3 DESIGN OF STRUCTURES, COMPONENTS, EQUIPMENT AND SYSTEMS

3.2.2 Summary of Application

Figure 3.7.4-1. Plot comparing the CSDRS derived OBE (a) and the site-specific OBE (b) with the other requirements used to determine an OBE exceedance.

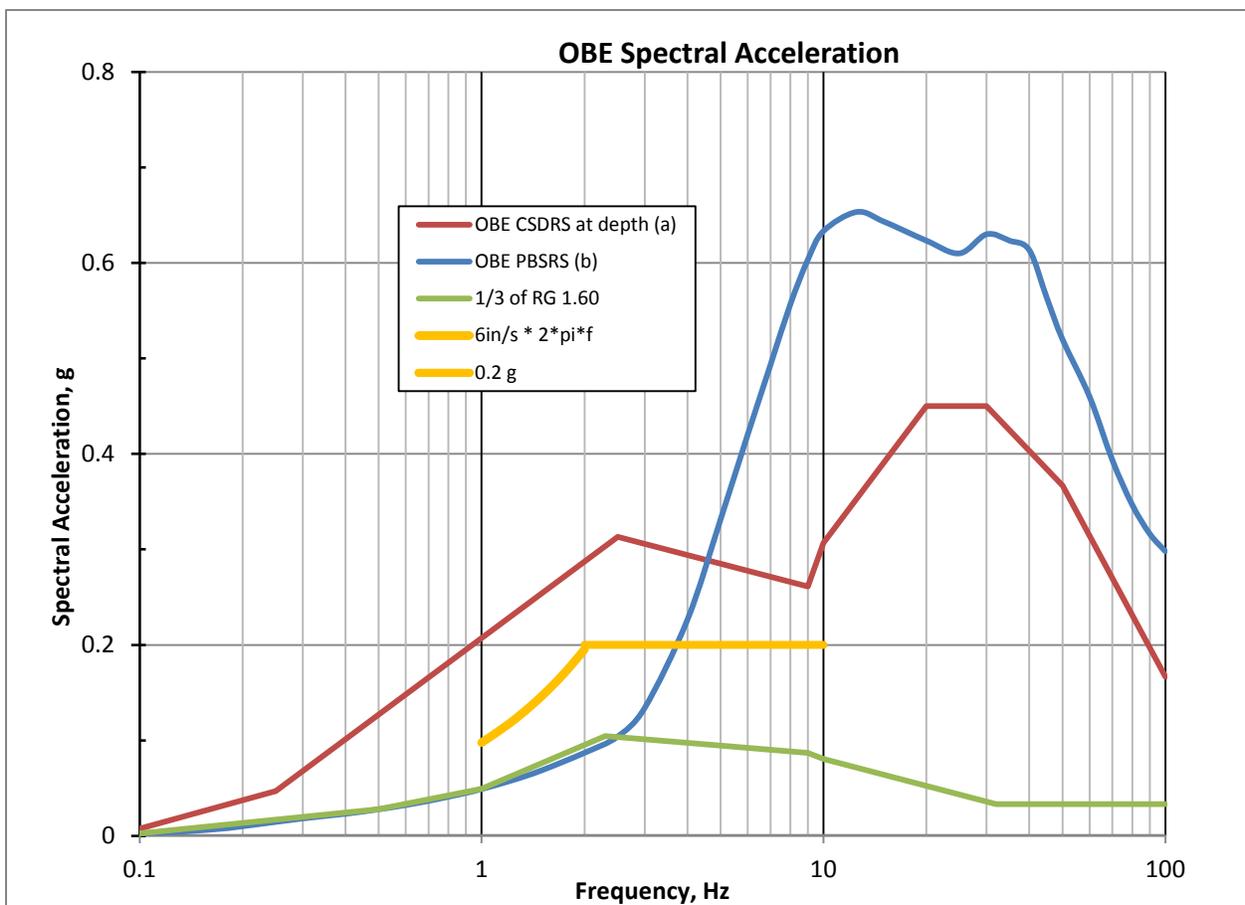
In RAI 3.7.4-2, the staff noted that the applicant considers two different spectra, the site specific SSE and the CSDRS, when determining if a recorded ground motion exceeds the OBE ground motion. The staff requested that the applicant specify how this definition of OBE exceedance meets the requirements of Appendix S to Part 50, and is consistent with the guidance in ISG-01.

In its response, the applicant stated that all safety related SSCs are designed, analyzed, and qualified to meet both the ESBWR CSDRS and the site-specific FIRS (Figure 3.7.4-1). The applicant also clarified that an OBE exceedance is declared when a recorded ground motion exceeds both the (a) CSDRS-derived and (b) site-specific OBE, but that these exceedances need not occur at the same frequency (i.e. envelope of (a) and (b) are not considered). For example, an earthquake response spectrum that falls below the envelope of (a) and (b), but exceeds (b) at low frequency and (a) at high frequency, would be considered an OBE exceedance, requiring plant shutdown if other criteria, as discussed in FSAR Section 3.7.4.4, are also met. Finally, the applicant stated that the consideration of (a) for determining the OBE at grade is conservative, because this selection neglects the effects of ground motion amplification or site response between the elevation of the RB/FB and CB foundations and plant grade.
